ADDENDUM NO. 1

**FORT WAYNE CHILDREN'S ZOO
VELDT BARN REPLACEMENT
MSKTD Project No. 8063
Wednesday, September 11, 2024**

This addendum is issued as a supplement to the drawings and specifications and shall be considered an integral part of the same.

SHEET NUMBER
C201

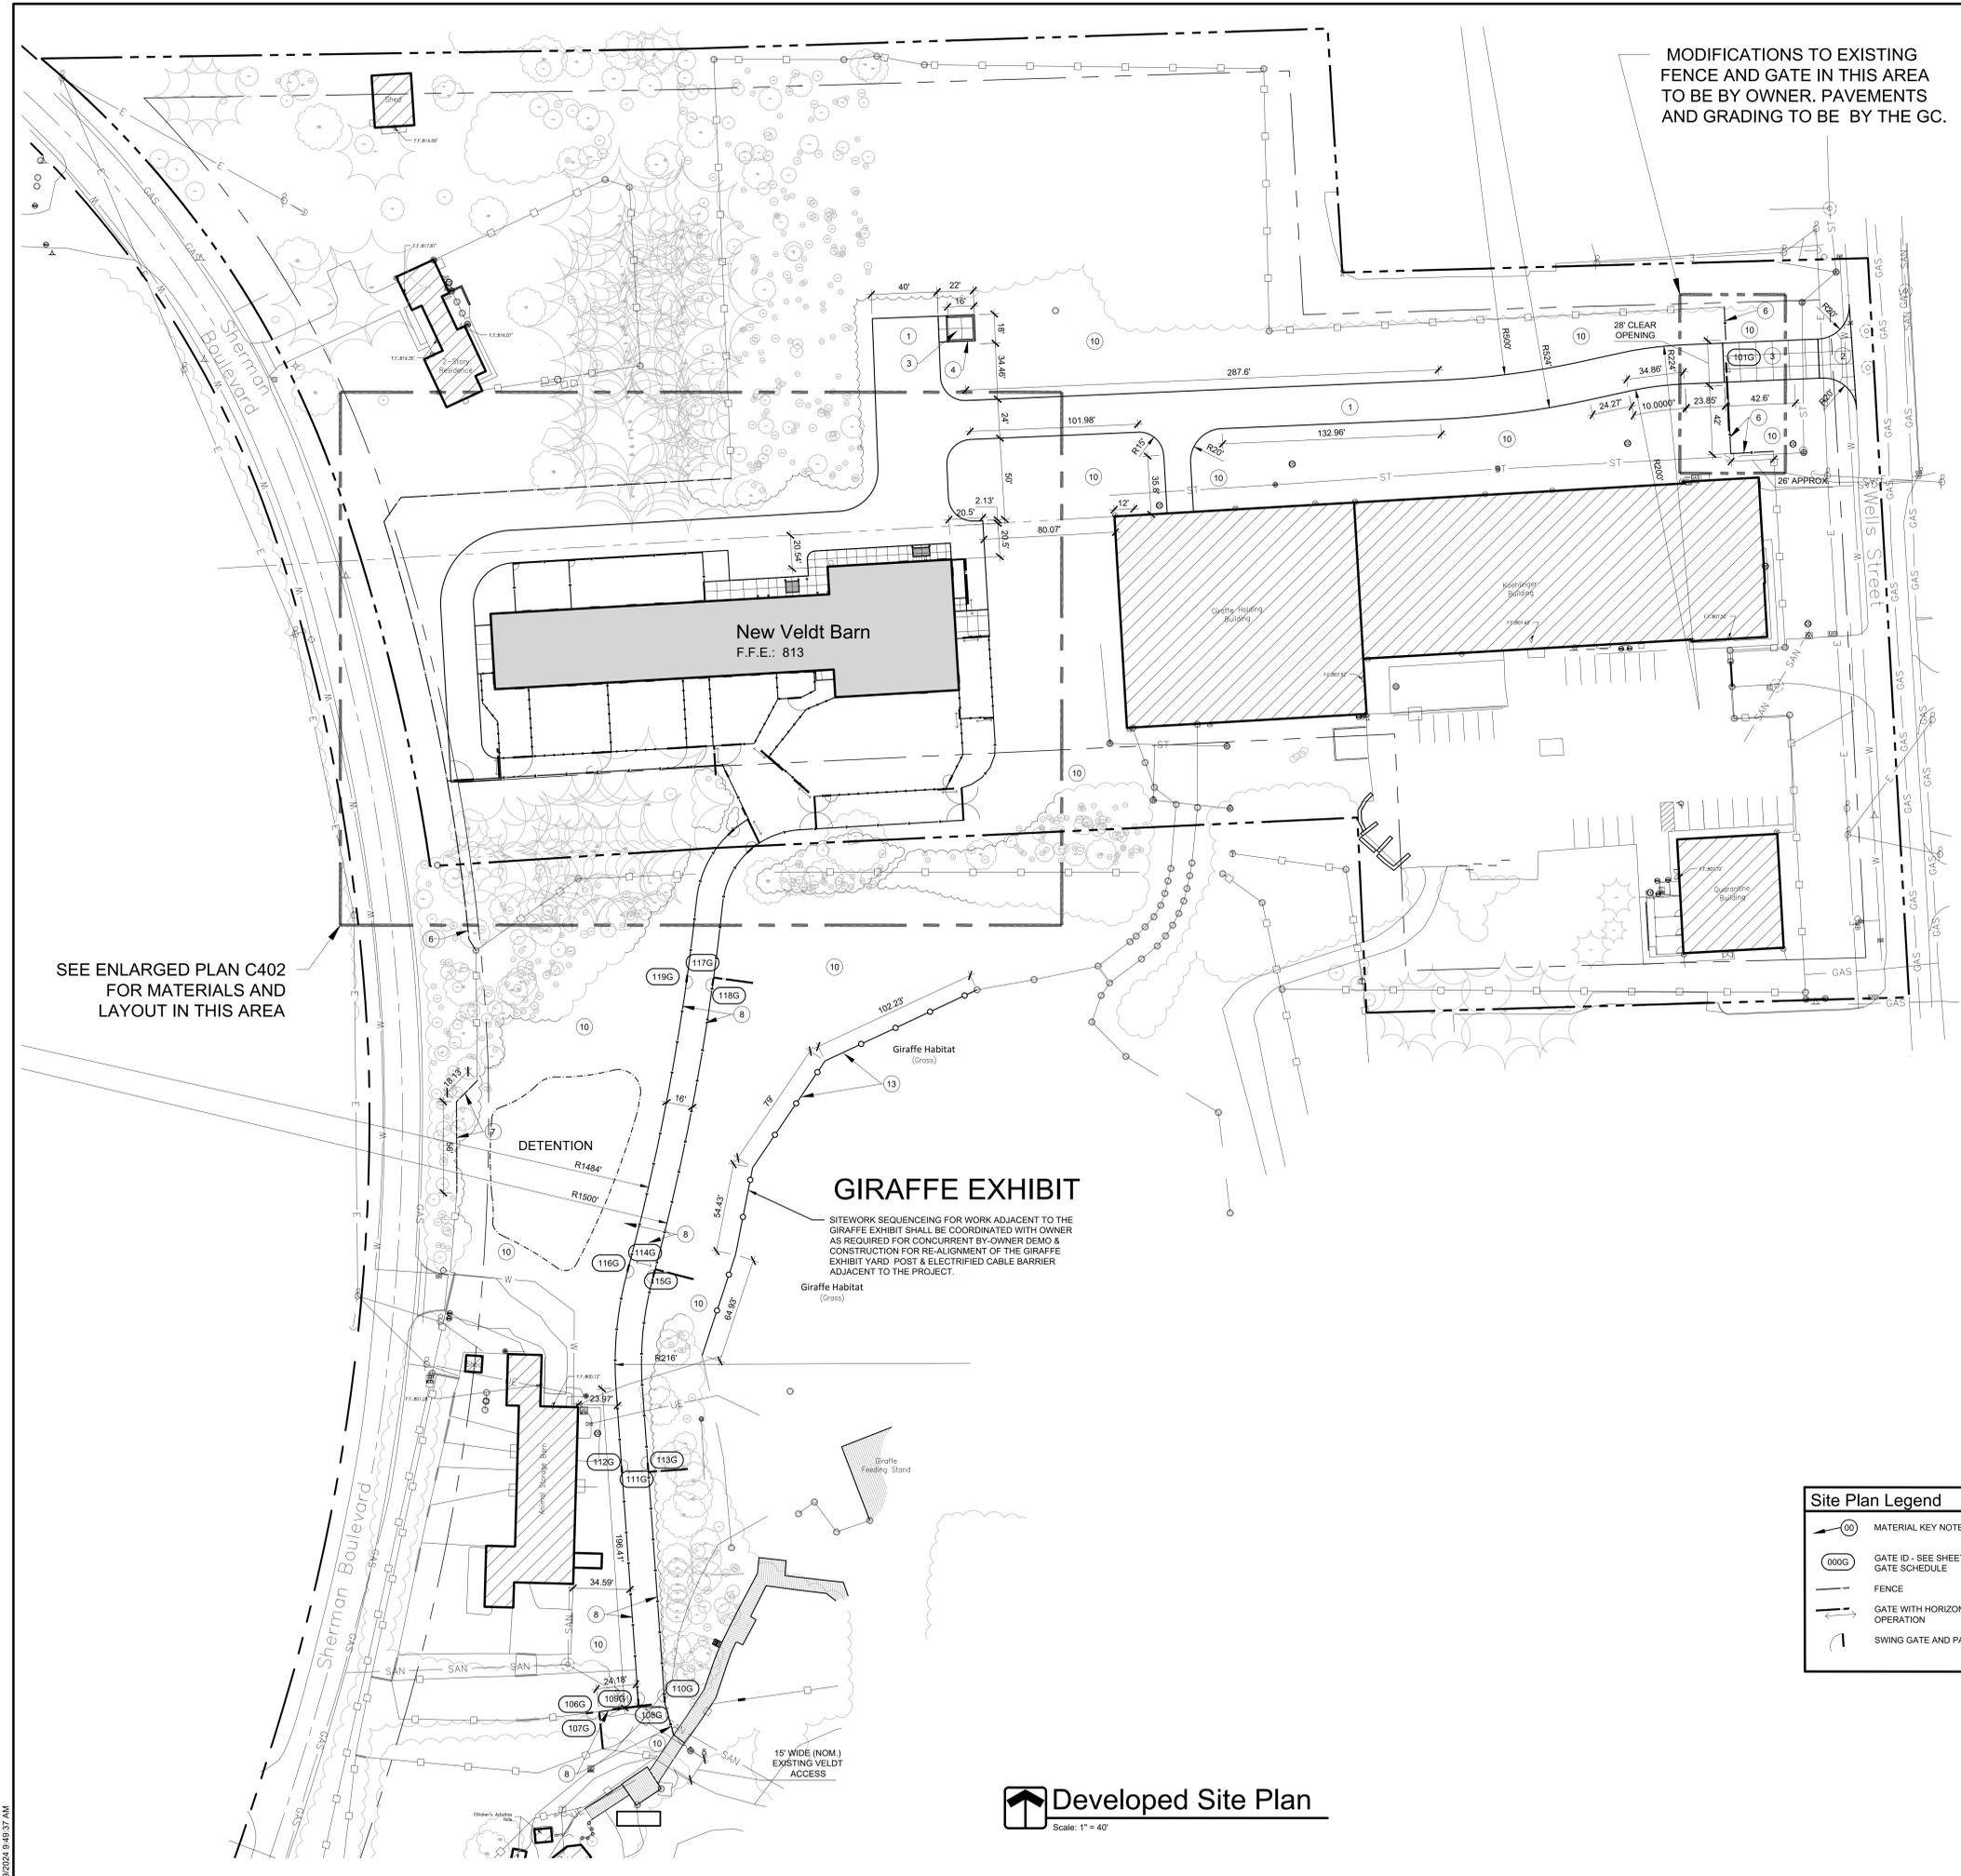
1.15	Drawing Sheet C201	Revise Grading & Utility Notes, Note 2 to read: Contractor shall coordinate all utility work with utility agencies. The new gas service line cost is to be coordinated for payment by the Owner directly to the utility. Contractor shall pay all other fees and cost charged by all other utility agencies to complete new construction.

SET DESCRIPTION
Bid Set
SHEET TITLE
Site Details
SHEET NUMBER

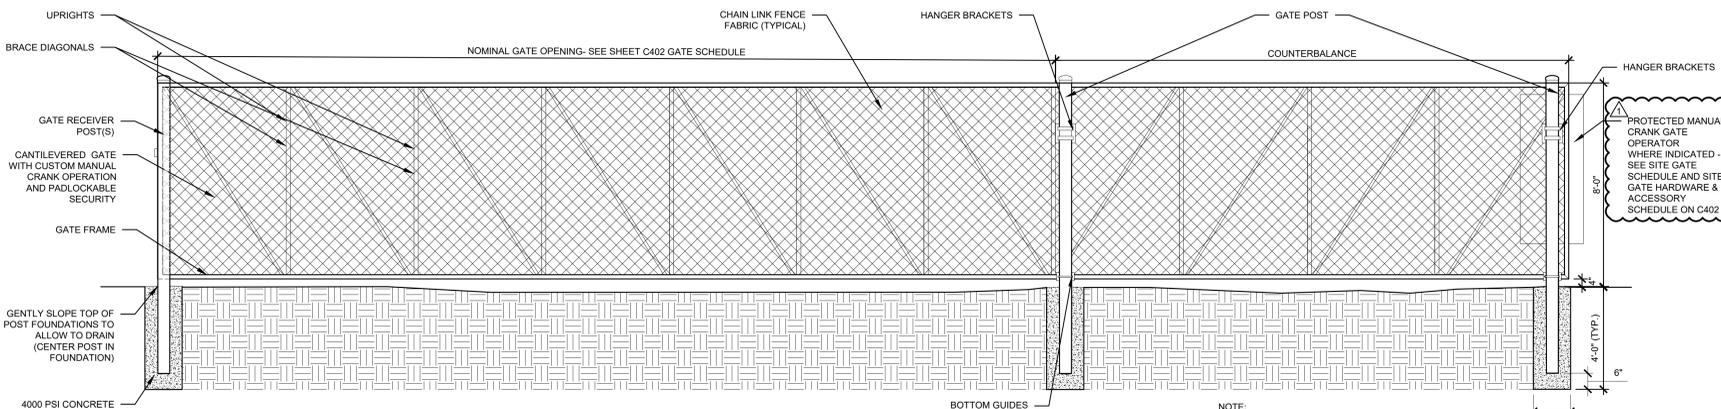
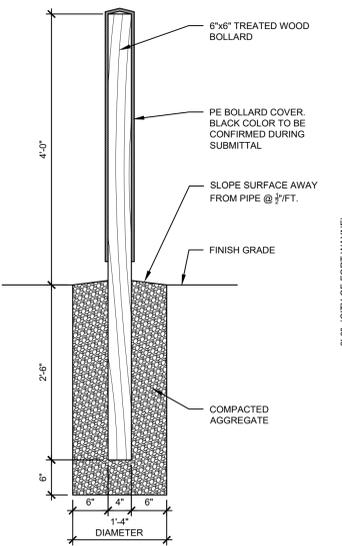
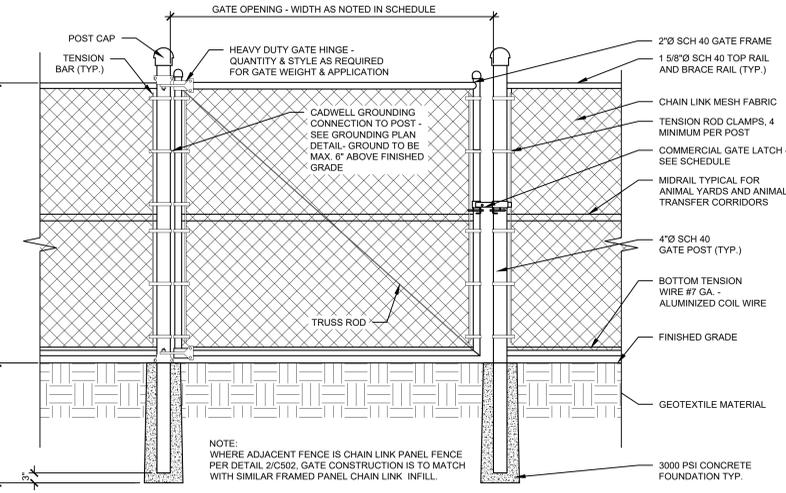
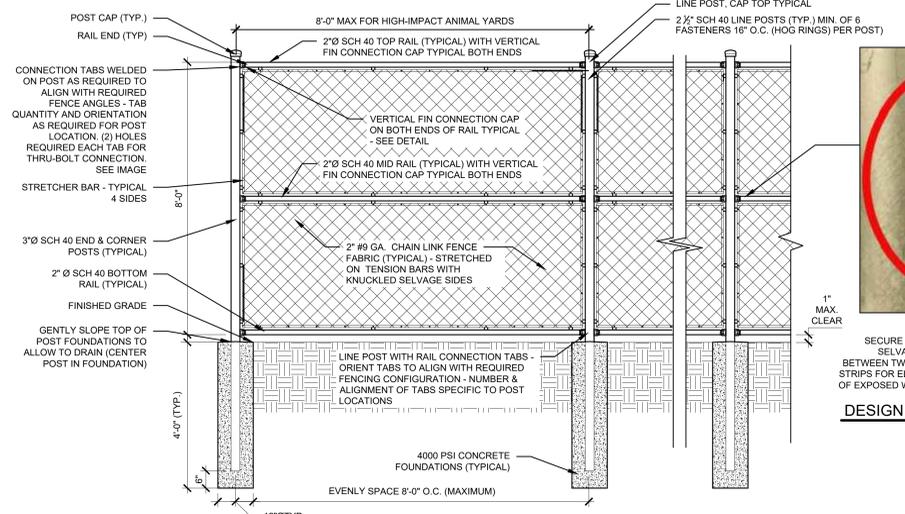
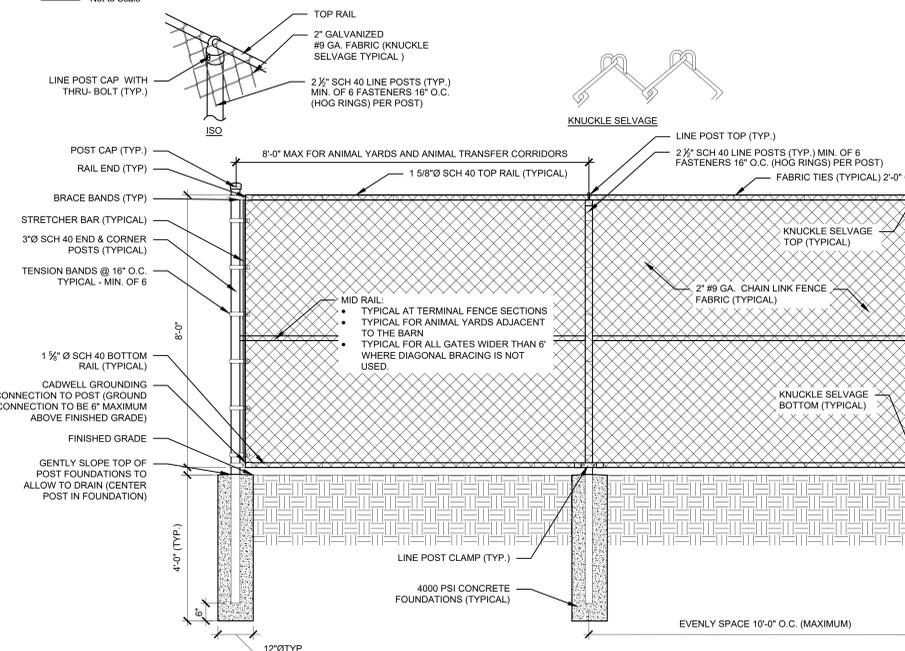
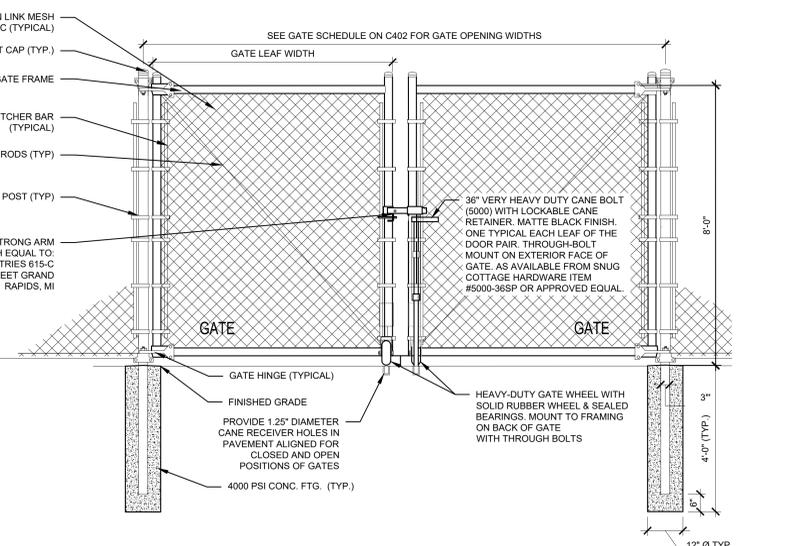
1.18	Drawing Sheet C501	Change Detail 9/C501 to reflect switch from "By Owner" Scope to "By G.C." scope. Change Detail 10/C501 to reflect switch from "By Owner" Scope to "By G.C." scope. and switch from powered, remote-controlled operation to manual slide operation.

<u>ITEM</u>	<u>LOCATION</u>	<u>DESCRIPTION</u>
1.19	Drawing Sheet C502	Change Detail 5/C502 to refer to C402 for Site Gate Schedule and to Site Gate Hardware & Accessory Schedule for manual crank requirement.

SET DESCRIPTION
SHEET TITLE Sanitary Drainage Plans
SHEET NUMBER

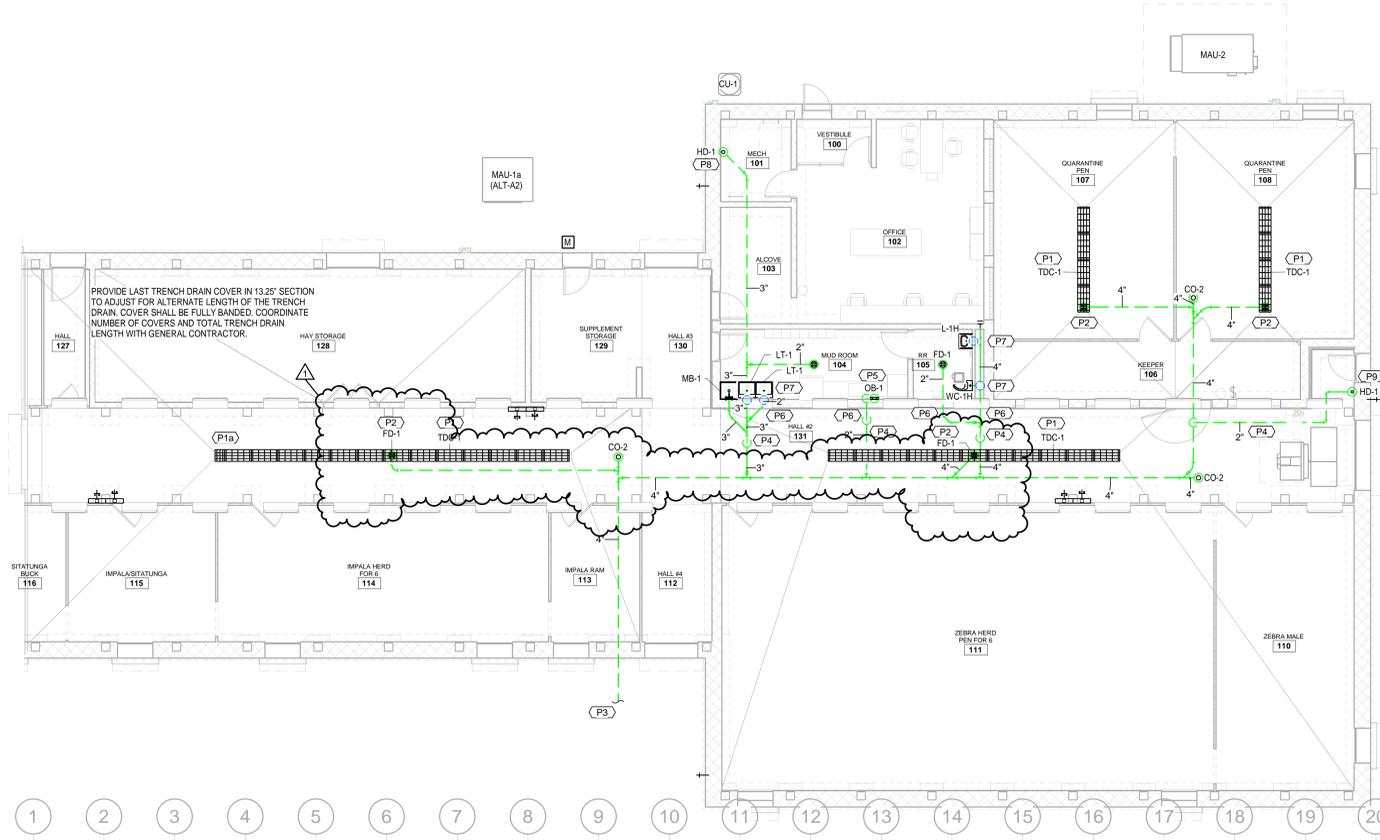
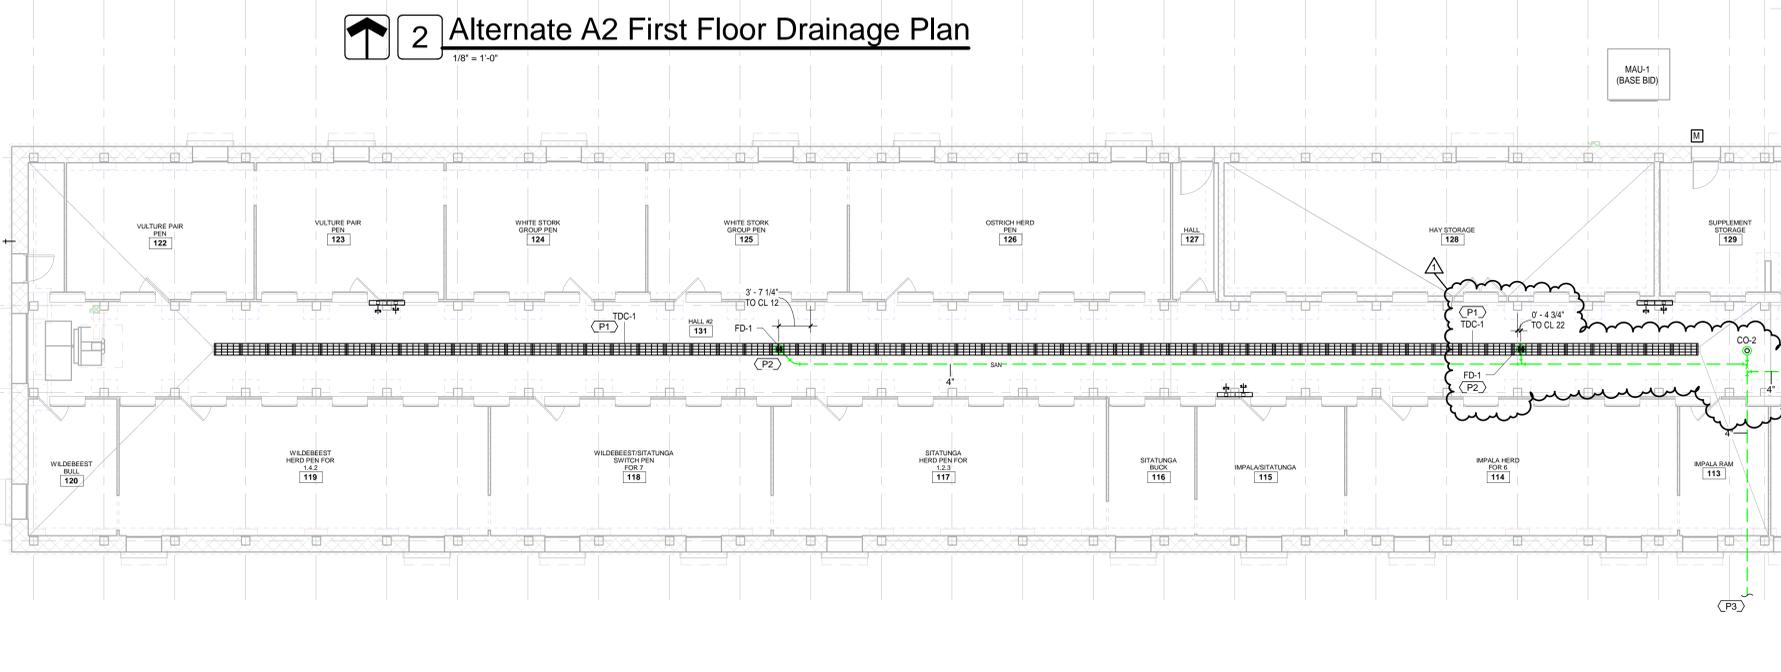
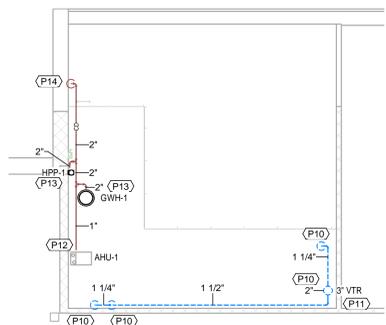
1.23	Drawing Sheets P201 & P501	Provide revised floor drainage and trench drain covers to accommodate splitting the cast trench in the floor as shown on the attached, revised sheets.
